CALL NO. 102
CONTRACT ID NO. 231341
ADDENDUM # 3

Subject: Fayette County, NH 2681 (037)
Letting October 26, 2023

- (1) Revised - Special Note - Pages 69-73 of 302
- (2) Revised - Proposal Bid Items - Pages 292-302 of 302
- (3) Revised Plan Sheets - T21, T77, T80, T82, T85, S006 for Item 28765 & S007 for Item 28766

ITEM NO.
7-113.02
SHEET NO.
S6

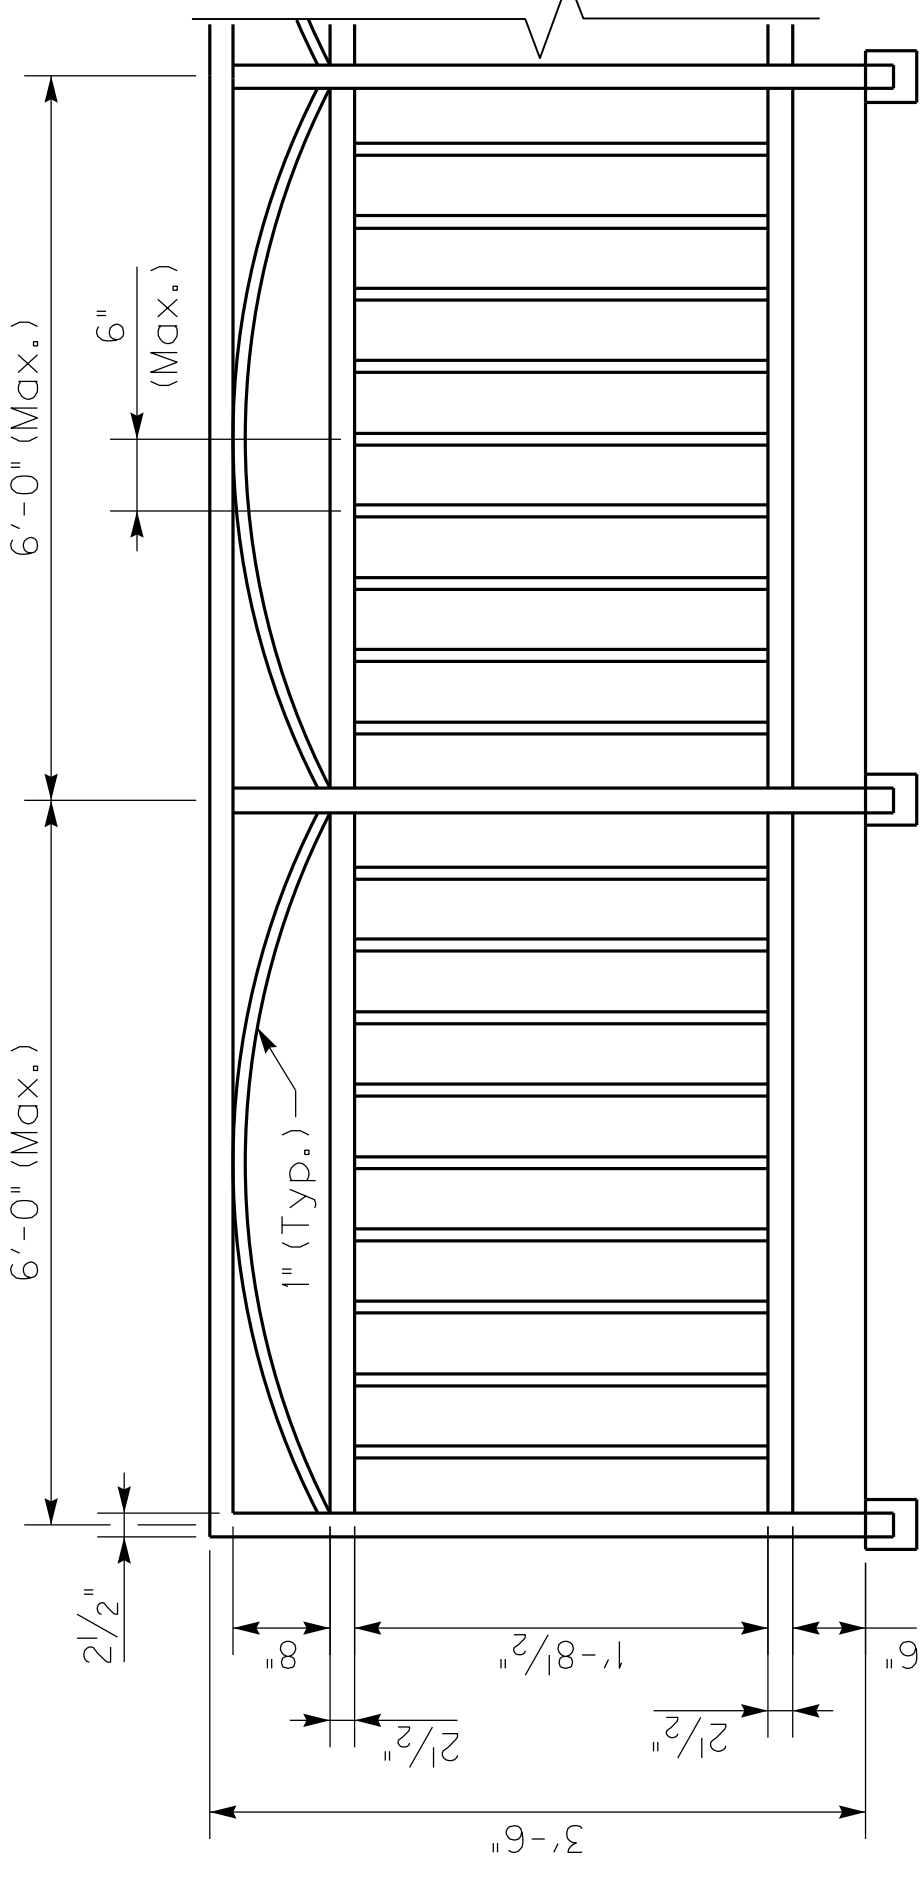
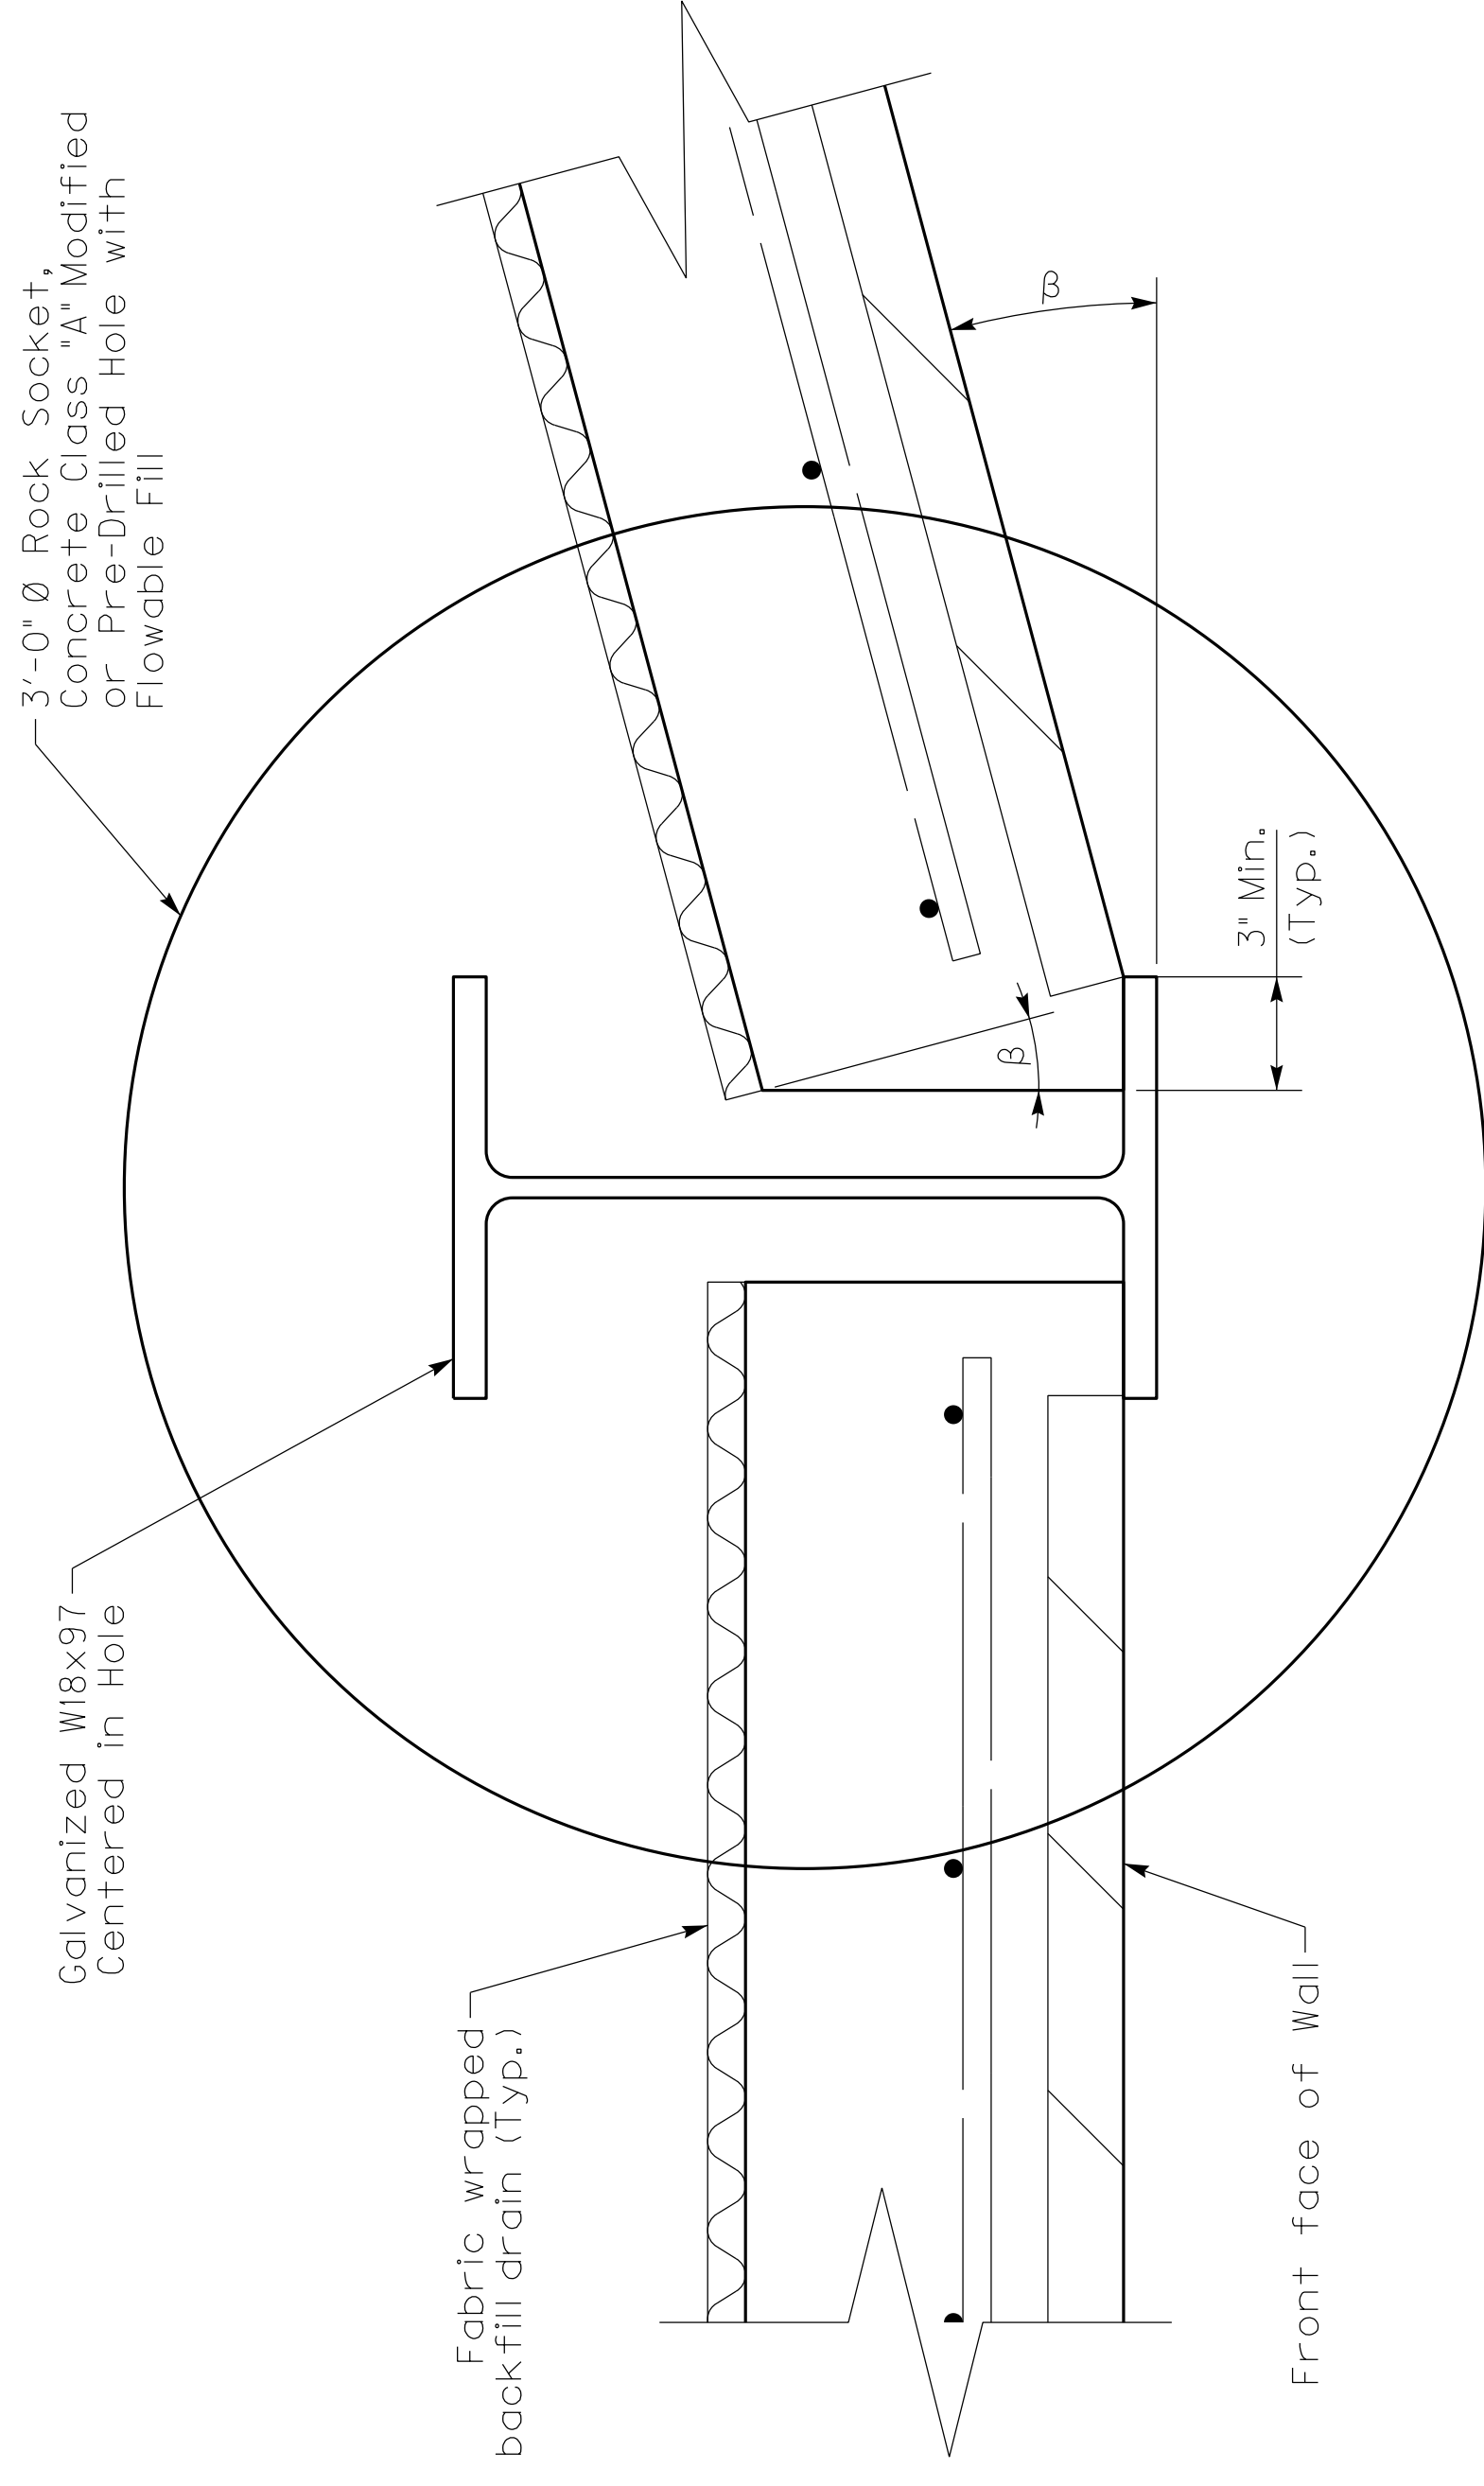
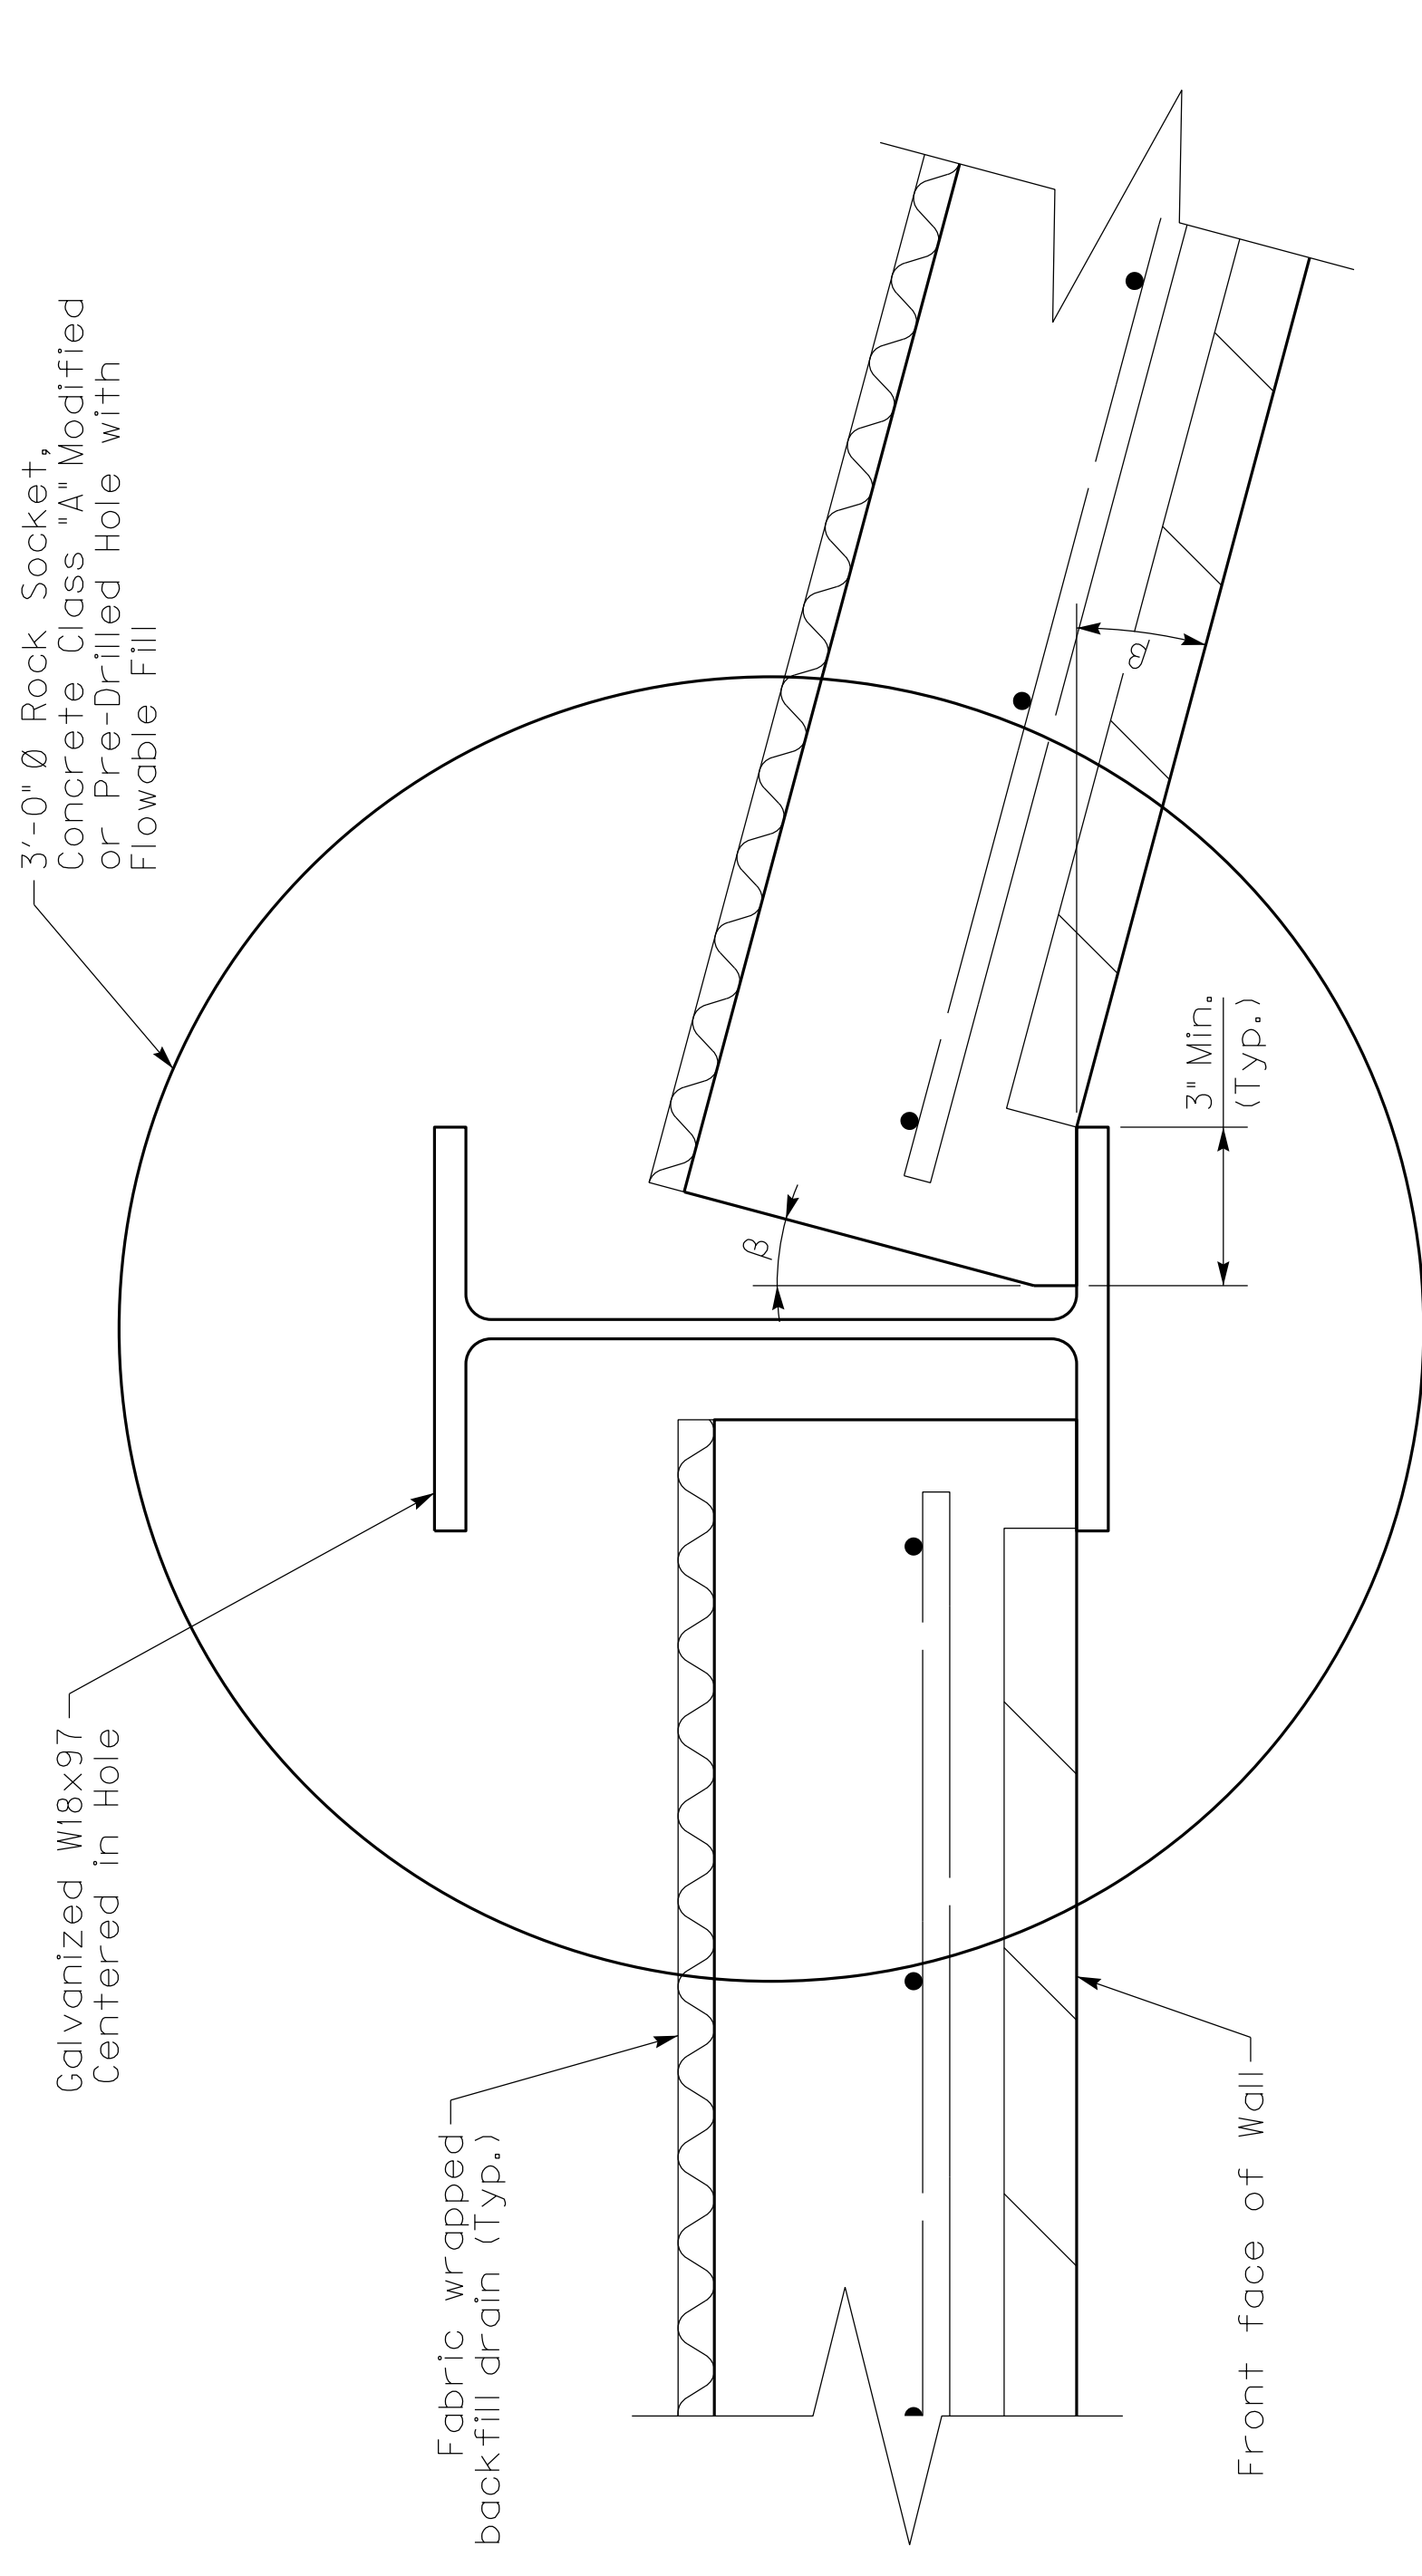
REVISION
Added Decorative Fence detail and notes

Fence components, internal connections, connection to concrete wall, and additional design parameters are the responsibility of the contractor. Ensure the design meets all applicable requirements of the AASHTO LRFD Bridge Design Specifications, 9th Ed.

Design calculations and plan details for the fence components, internal connections, and connection to concrete wall shall be prepared and sealed by a Professional Engineer licensed in the Commonwealth of Kentucky. These shall be submitted to the Engineer for approval. Fabrication and installation shall not commence prior to approval. All labor associated with this shall be considered incidental to the unit bid price for the decorative railing.

The fence components and connections shall be steel and shall be powder coated. After galvanization in accordance with the manufacturer's recommendations. The contractor will be required to provide and test multiple color options for final approval by the Engineer. Fence components and coating shall include a 10-year warranty. All labor and materials associated with this shall be considered incidental to the unit bid price for the decorative railing.
